7. Sweet Spot Subdivision: KPB File 2024-069 Geovera, LLC / Shafford Location: Hutler Road & East End Road Fritz Creek Area / Kachemak Bay APC

ITEM #7 - PRELIMINARY PLAT SWEET SPOT SUBDIVISION

| KPB File No. | 2024-069 |

STAFF REPORT

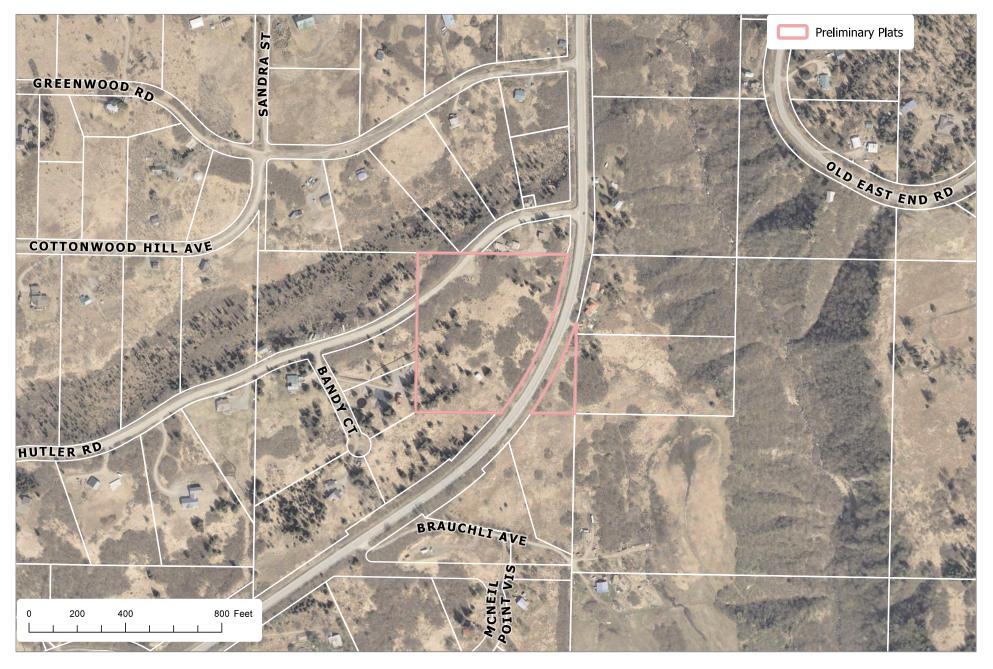
With this platting action, Hutler Road will be dedicated to the Kenai Peninsula Borough, and East End Road will be dedicated to the State of Alaska. *Staff recommends* the surveyor add the appropriate Certificate of Acceptance for the dedications to the drawing.

A 33' section line easement affects the property on the east side and is shown correctly across proposed Lot 4. **Staff recommends** the easement line be continued north through the East End Road right-of-way dedication.

There appears to be an encroachment of a driveway across the northern tip of proposed Lot 4. **Staff requests:** Surveyor confirm whether an encroachment affects the plat. **Staff recommendation**: grant driveway easements over the existing travel way to eliminate the encroachment. Since the driveway easements would be private, easements should be created by separate document, recorded and then shown or noted on the final plat.

The appropriate utility easements and notes appear to be depicted on the plat. **Staff recommends** the surveyor show the 10' utility easement on the typical detail

Update KPB file number to 2024-069. Check total acreage.

There appears to be an encroachment of a private drive across the northern tip of proposed Lot 4.

20.60.200. Survey and monumentation. **Staff recommendation**: comply with 20.60.200. Please provide cap detail for found monuments. Check cap date for monuments set this survey.

Wetlands

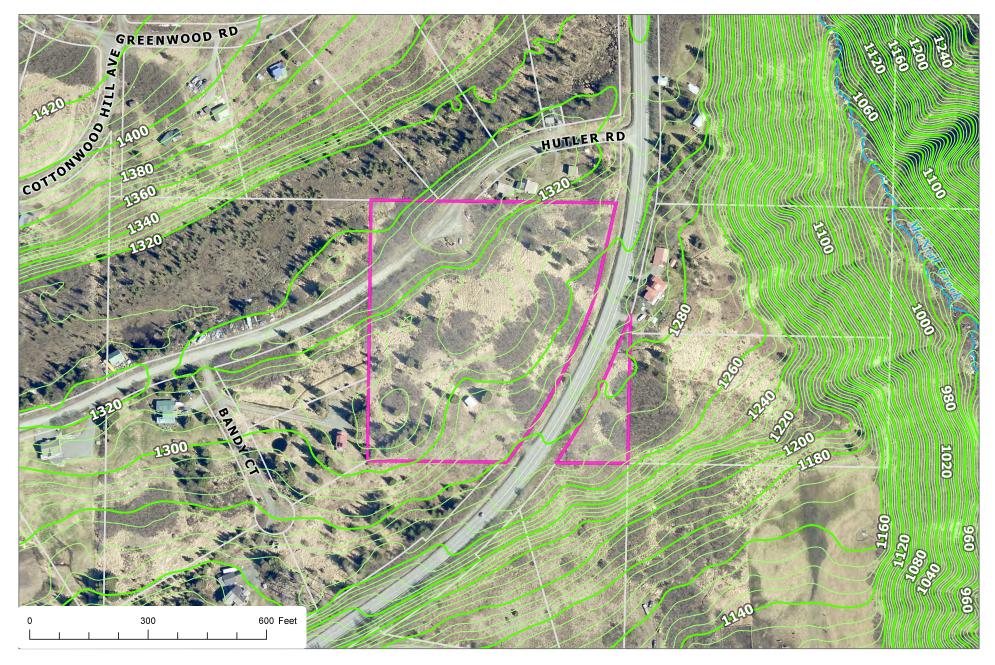
There are wetlands across proposed Tract A of this plat according to KPB KWF Wetlands Assessment. The appropriate note appears to be added to the plat addressing wetlands development within the borough. River Centre review did not identify any flood hazard or floodway issues.
